**MWO 9-1005-201-30-6**

### MODIFICATION WORK ORDER

**MODIFICATION OF MACHINE GUN, 5.56MM, M249  
(NSN 1005-01-127-7510) (EIC: 4BG) Automatic Rifle Role  
(NSN 1005-01-451-6769) (EIC: 4BK) Light MG Role**

MWO 9-1005-201-30-6, 15 August 2005, is changed as follows:

Figure 1

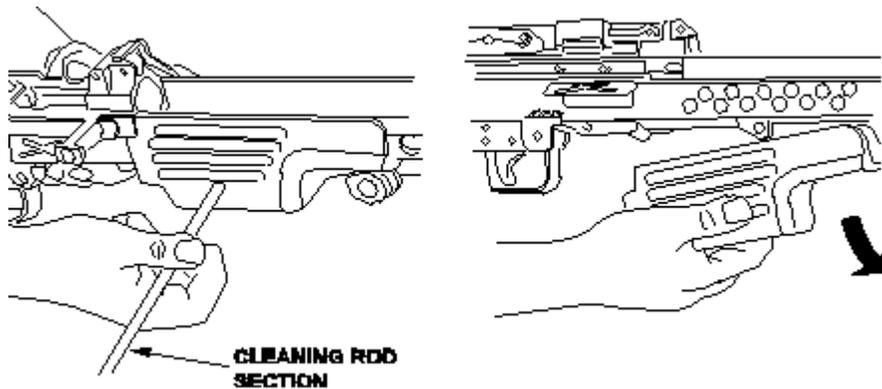
- (2) (Figure 1) Remove the handguard by pushing handguard retaining pin to the left using a cleaning rod section, then remove handguard downward.

Figure 2

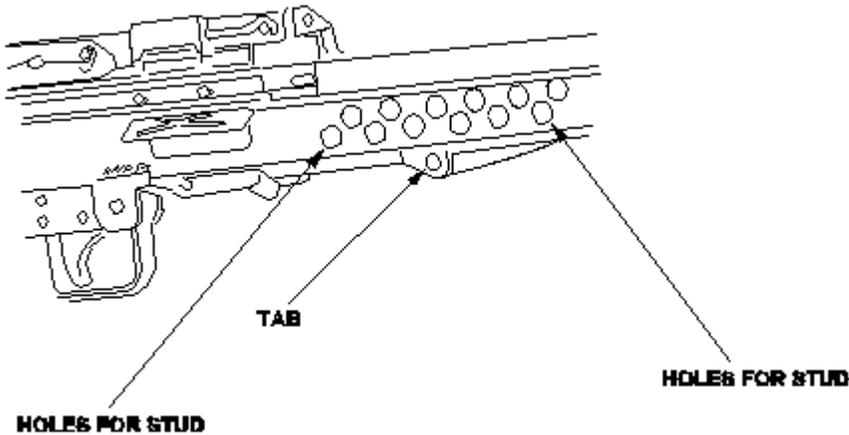
- (3) (Figure 2) Install the right adapter rail (the one with two rails) on the right side of the receiver. This rail has a relief cut for the tab located on the bottom of the receiver to allow the rail to fit flush against the bottom of the receiver, and also allows the two studs to fit into the holes on the side of the receiver.

Figure 3

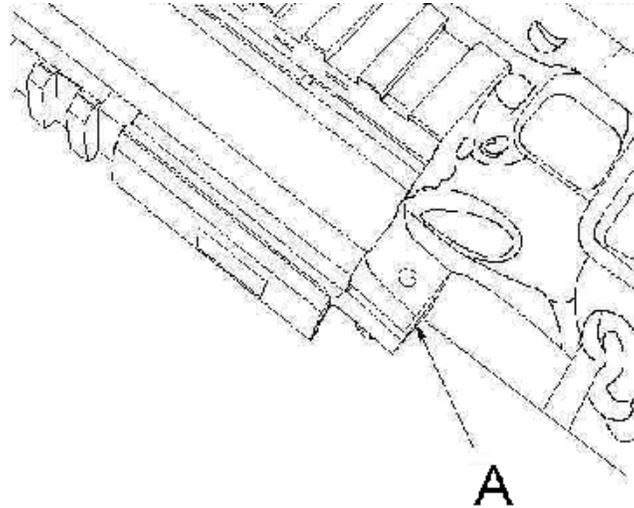
(4) (Figure 3) Install the left side adapter rail so the adapter fits on the bottom of the receiver and ends of the two adapter rails are aligning with each other. The two studs will also fit into the holes on the side of the receiver. Illustration above shows that the rails should be flush against the bottom of the receiver (A).

Figure 4

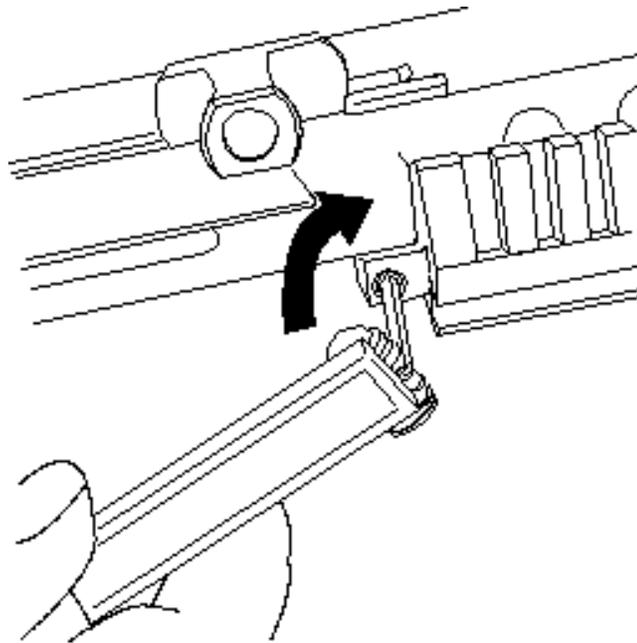
(5) (Figure 4) Using a 9/64 hex key wrench, install the two screws (one at each end of the adapter rail) from the right side of the adapter rail and tighten snug. Do not over tighten.

Figure 5

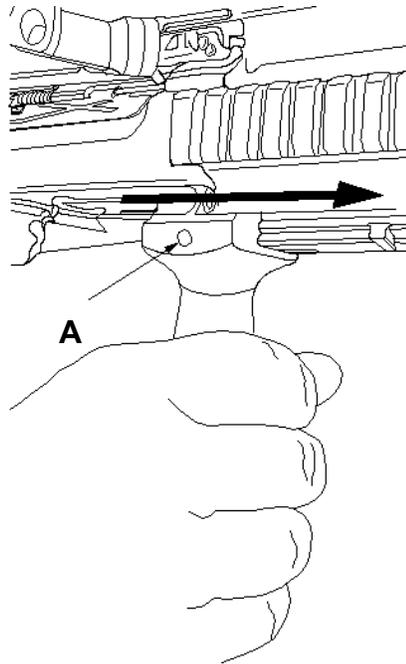
(7) (Figure 5) Install the vertical pistol grip on the bottom rail by sliding it from the rear to the front until the locking lug of the vertical pistol grip lines up with a slot on the adapter rail. Adjust accordingly to the length of the operator's arm. View rail slot through hole in vertical pistol grip (A).

Figure 6

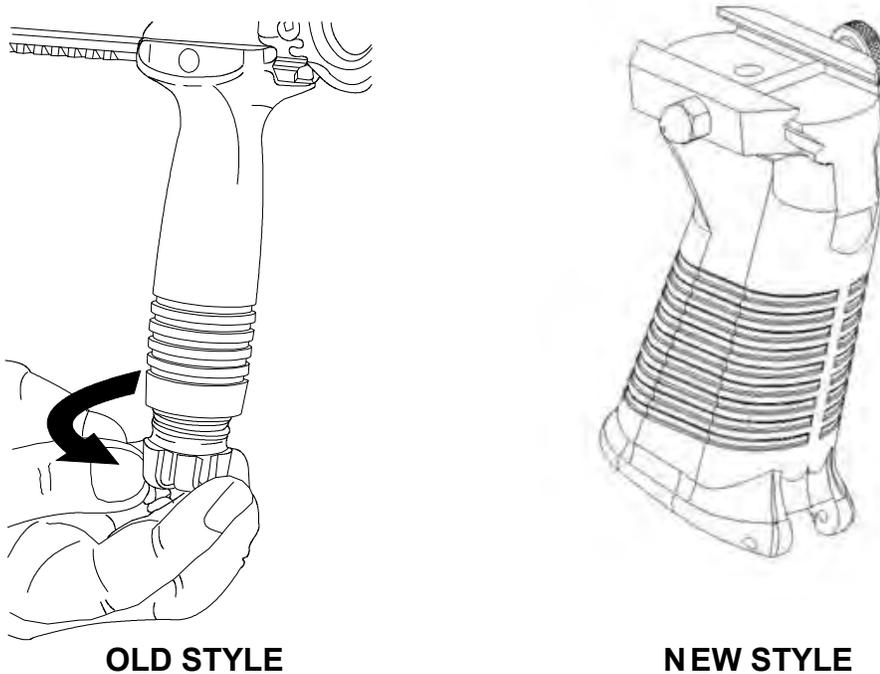
(8) (Figure 6) Tighten the O-ring clutch on the bottom of the vertical pistol grip by turning the clutch to the right.

Figure 7

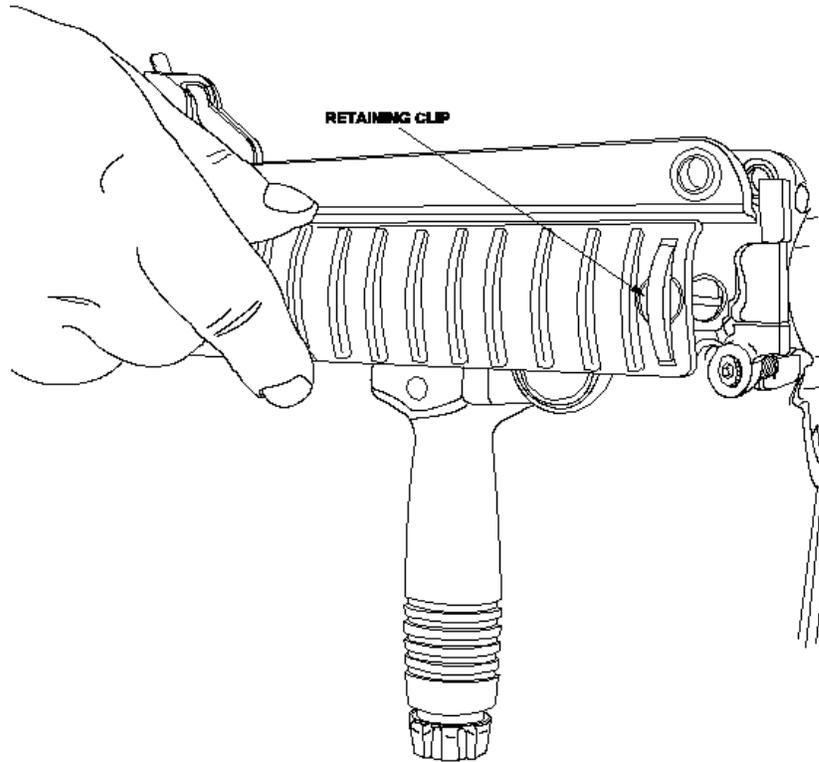
(Figure 7) Rail covers are quickly attached and detached from the adapter rail. A retaining clip at one end of each rail cover automatically engages cutouts positioned at either end of the three rail sections. To slide a rail cover beyond a cutout, or to remove it, slide it in the desired direction while applying thumb pressure to the retaining clip. Illustration above shows rail cover in full rearward position.

(9) (Figure 7) To cover both side rail surfaces, install the rail covers from the muzzle end of the adapter rail with the retaining clip forward. To cover the bottom rail surface, install from the rear with the retaining clip forward.

**Figure 8**

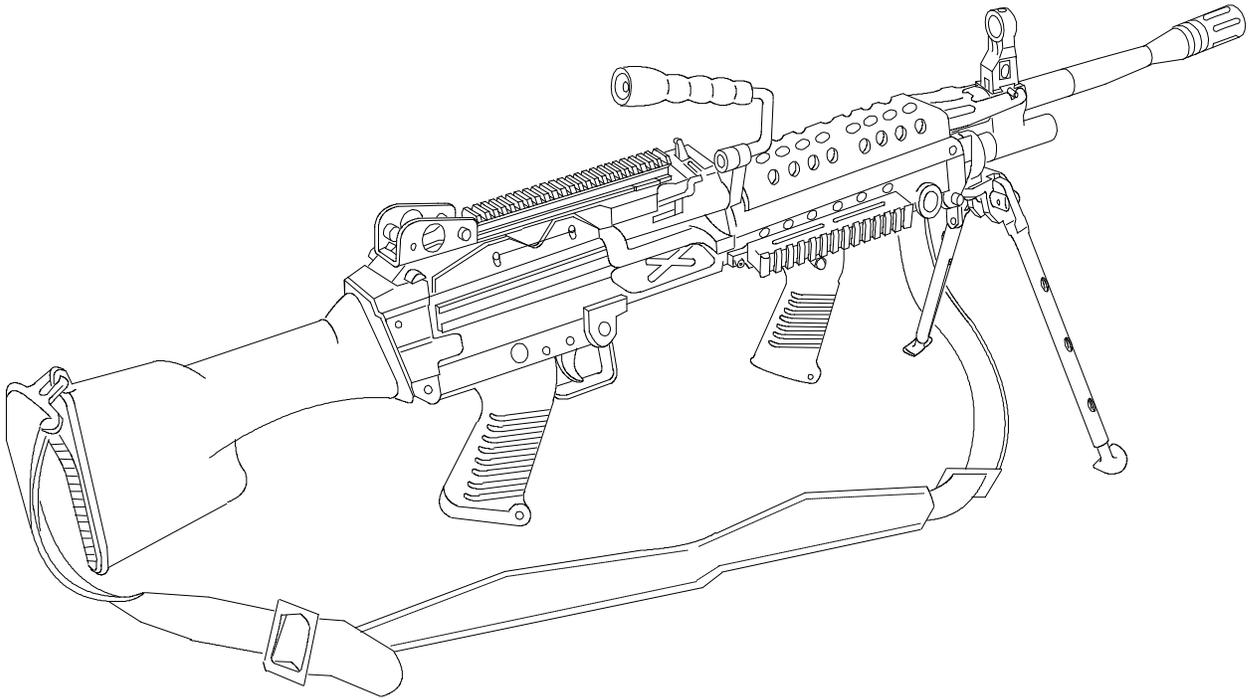
**16. MODIFICATION IDENTIFICATION.** No change in NSN, nomenclature, LIN or model designator is made by this MWO. The application can be verified by visual examination of the receiver assembly for a MIL-STD-1913 Rail. See Figure 8 below for illustration of the M249 MG after completion of this MWO.
